PERMIT# 25BLD-03329 -- ADDENDUM
DEBBIE AKINS - 637 FIELDCREST DR, CRESTWOOD MO 63126
SECTIONAL DIAGRAM OF ROOF AND EXTERIOR WALL CONSTRUCTION

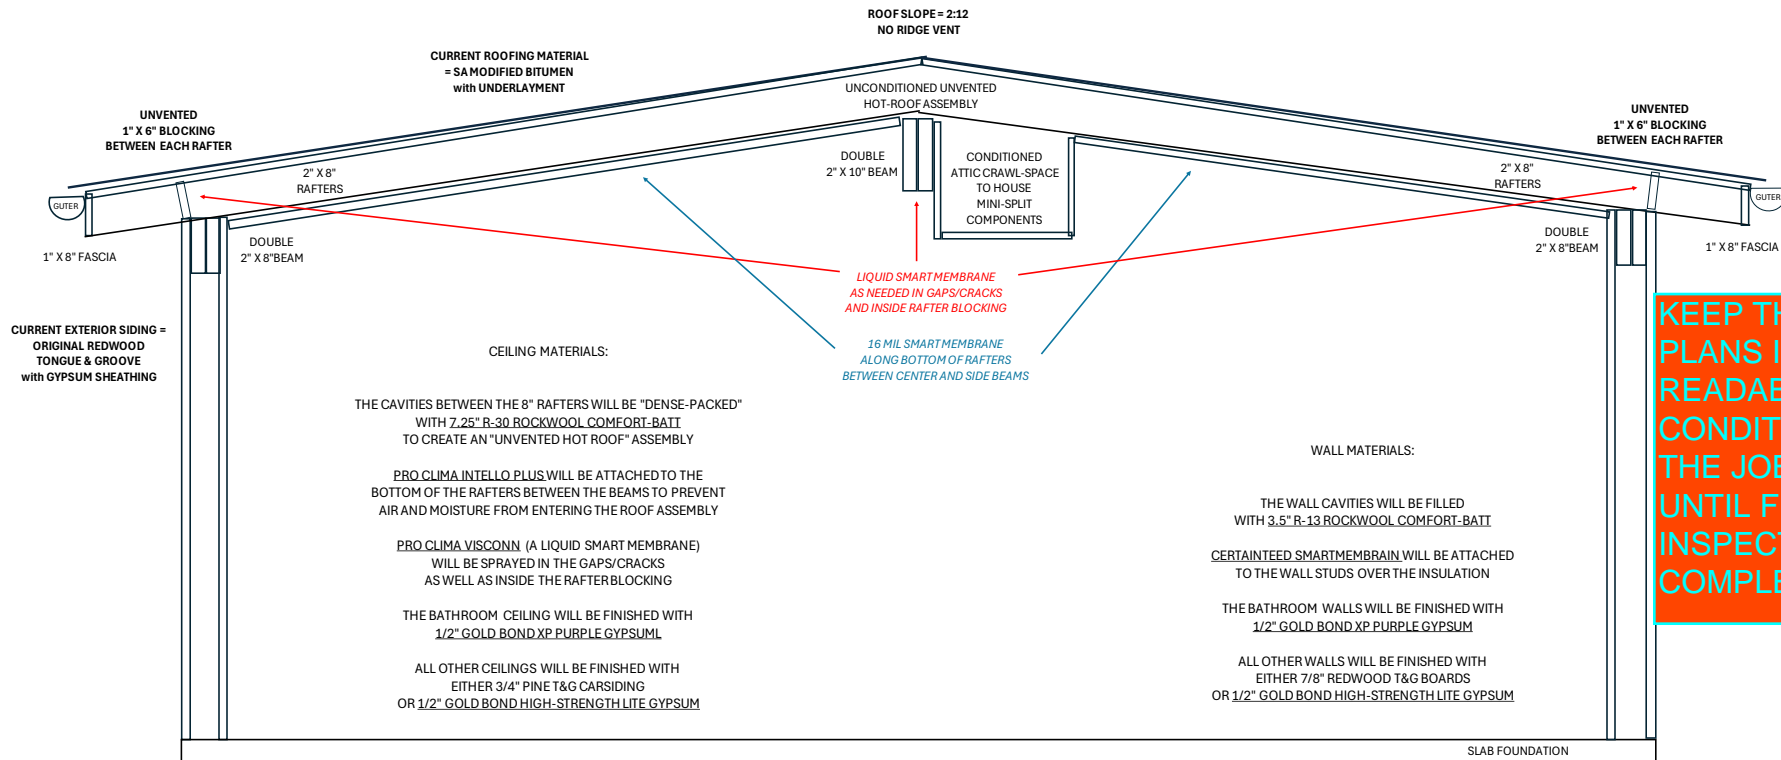
This Addendum is being submitted so as to (1) clarify the roof construction and to (2) update the planned ceiling and wall materials to be used. This is a Mid Century Modern house built in 1952 in a historic neighborhood. The original roof was tar and gravel, but it has been updated to a rolled SA Modified Bitumen. The roof slope is 2:12, rendering it virtually flat. Multiple roofers have advised against installing a ridge vent on such a low-pitch roof, and the cost to do so at this point would be considerable. The roofer as well as numerous house science consultants have recommended densely insulating and tightly sealing the ceiling cavity in a fashion referred to as an "unvented hot roof" assembly. The small attic crawl space will purposely become a conditioned space that will be used to house the Mini Split Heat Pump branch box and conduit. This will help to ensure these components do not condensate. The diagram below is intended to provide the details of this assembly, as well list the specific materials that will be used. Additionally, photos of the home have been provided on the following pages.
